Docket No. 50-336
B14788

Millstone Nuclear Power Station, Unit No. 2
Proposed Revision to Technical Specifications
Engineered Safety Feature Actuation System Instrumentation

Discussion of Safety Evaluation
Millstone Unit No. 2 ESFAS Auctioneering Modifications

Figure 1 ESFAS Sensor Cabinets

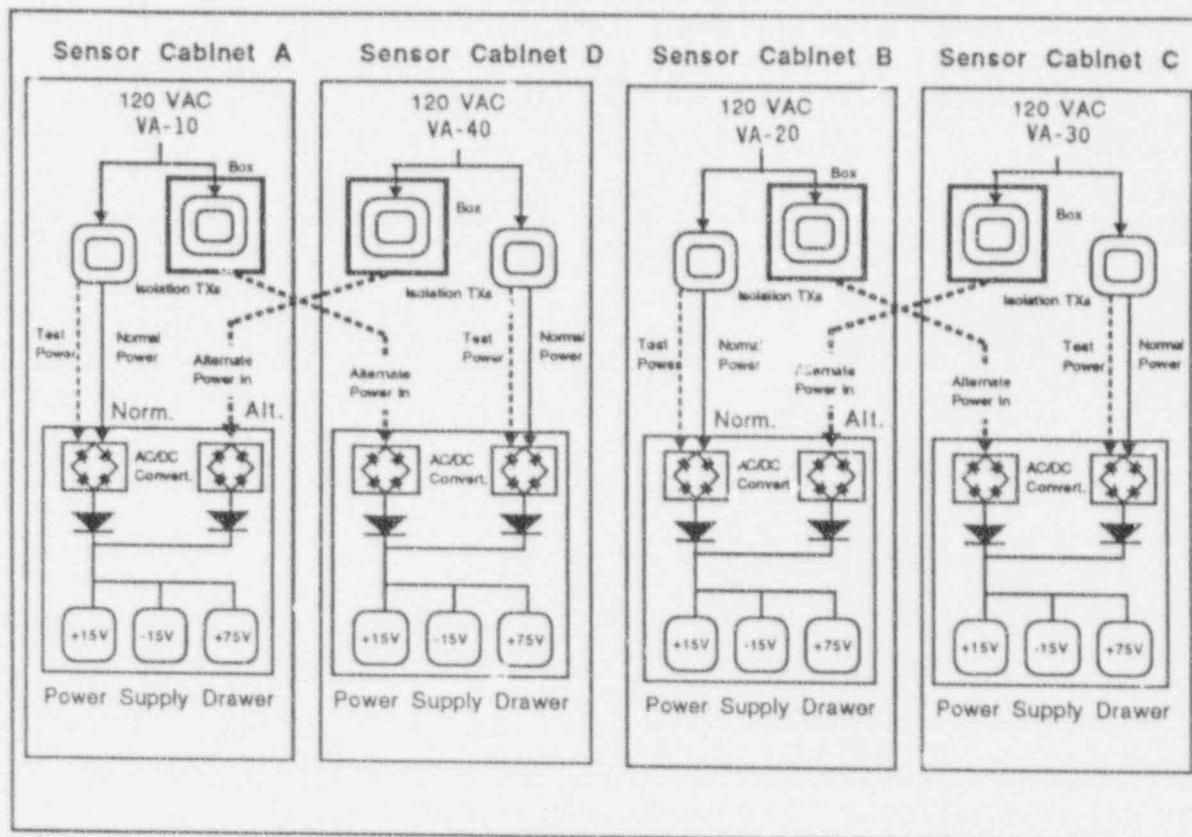
Figure 1 provides a block diagram of the ESFAS sensor cabinets.

Each sensor cabinet will be provided with two isolation transformers. One transformer will be mounted on a support plate open to the cabinet and the second transformer will be housed inside a metal enclosure. The transformer that is open to the cabinet will provide the normal and test power for the power supply drawers. This transformer augments the existing protective devices. The transformer inside the enclosure provides the alternate power for the corresponding cabinet (A backs-up D, B backs-up C and vice-versa). Within each cabinet, both the normal and the alternate AC/DC converter will remain energized. If a failure were to occur with the normal power supply, power would automatically be supplied from the alternate source. There is no logic or switching required. A second tap off the normal transformer provides a lower voltage for testing the auctioneering circuitry. During testing, the normal AC input to the power supply drawer is disabled. The "test power" voltage

is lower than the backup voltage supplied by the alternate isolation transformer but sufficiently high to power the cabinet if the alternate source is not available. (A multimeter check verifies the alternate source diode conducts during the test). Both power supplies in the power supply drawer are also equipped with indicator lights.

The isolation transformers are a split bobbin type design. The secondary windings are physically separated from the primary windings, thus providing the isolated power to sensor cabinets.

A series of fuses are an integral part of the isolation transformer. The fuses limit the duration of a fault current so that a short circuit downstream of an isolation transformer will not adversely affect the associated 120 volt vital AC power source (VA-10, 20, 30, or 40). A thermal cutout, located on the primary windings, provides protection against potential overheating due to a sustained short circuit. Circuit breakers also exist between the transformers and the vital AC panels. The inherent impedance of each isolation transformer ensures that the

Adequate isolation is established by the use of split bobbin isolation transformers, integral fuses, and thermal cutouts on both the original (normal) power supply and on the new alternate power supply. The alternate supply connection between cabinets is downstream of the isolation transformer. This ensures that within each cabinet, only one channel of vital AC is present above the isolation devices.
